<b>Notice of Allowability</b>	<b>Application No.</b>	<b>Applicant(s)</b>	
	10/791,581	LIANG, GEORGE	
	Examiner Richard Edgar	Art Unit 3745

**FIG. 2**

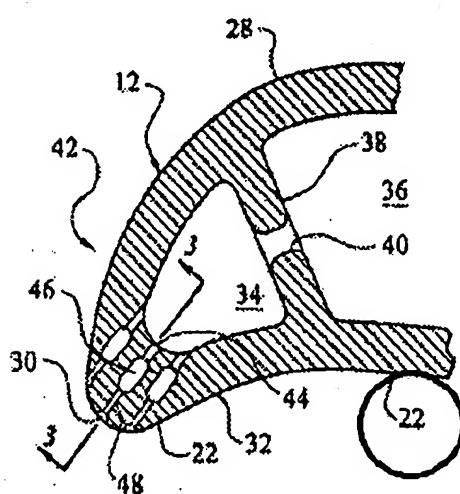
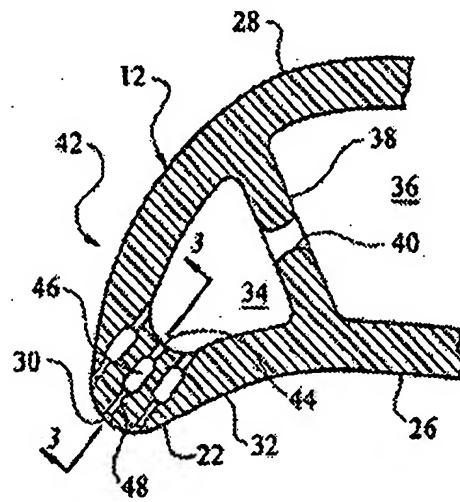
The numeral "22" in Fig. 2 should be -- 26 --. See reproduced figures below

wherein the drawing on the left identifies the error and the drawing on the right shows the correction. In order to avoid abandonment of the application, applicant must make this drawing change.
